MEMORANDUM

From:	Ben Amey Development Control		
Service	WBC Highways	App No:	251105
Address:	The Sapphire Centre, Fishponds Road, Wokingham, RG41 2QL		
Proposal:	Proposed Extension to the Rear of the Existing APACOR Facility by Connecting with an Existing Commercial Building to the Rear with associated works		
Site Visit Made:	Yes (10 th and 11 th June 2025)

Consultation Response

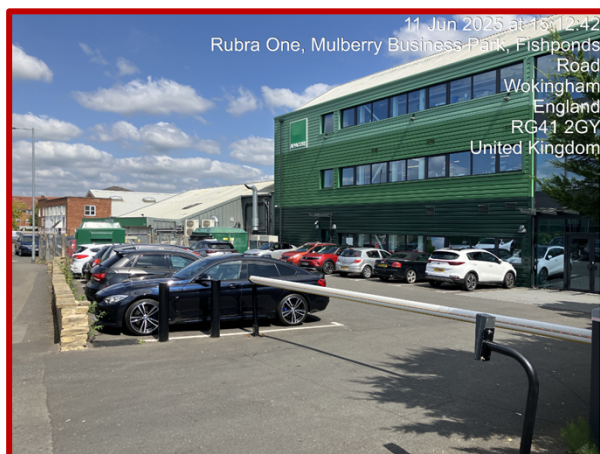
5. The LHA require dedicated parking bays for lorries/vans on site. The site does not appear to have suitable capacity to accommodate a greater number of deliveries associated with a larger warehouse and increased no. of goods on site (or larger vehicles). On a site visit, two delivery vans were observed blocking the access and were required to reverse into the site. This is shown in the photo below:

Aisle Manoeuvring Space)	Constructed Parking Layout

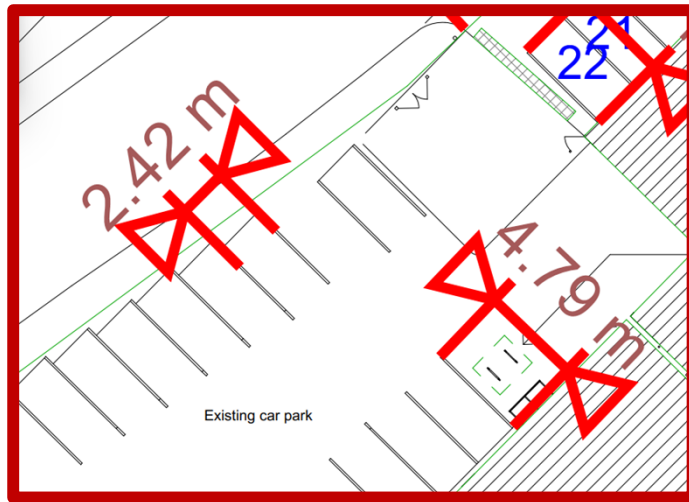
10. Furthermore, 7 of the proposed car parking spaces on the proposed site plan do not provide suitable manoeuvring space to ingress/egress each of the car parking spaces. The aisle only measures 2.62m wide which will not be sufficient to allow vehicles in and out. An aisle width of 6.0m would be required (As per paragraph 8.3.51 of Manual for Streets).

11. The layout of these spaces also differs from the way they have been recently constructed on site.
12. A screenshot indicates this problem below. These spaces should be reconfigured otherwise they cannot be counted as useable parking spaces.
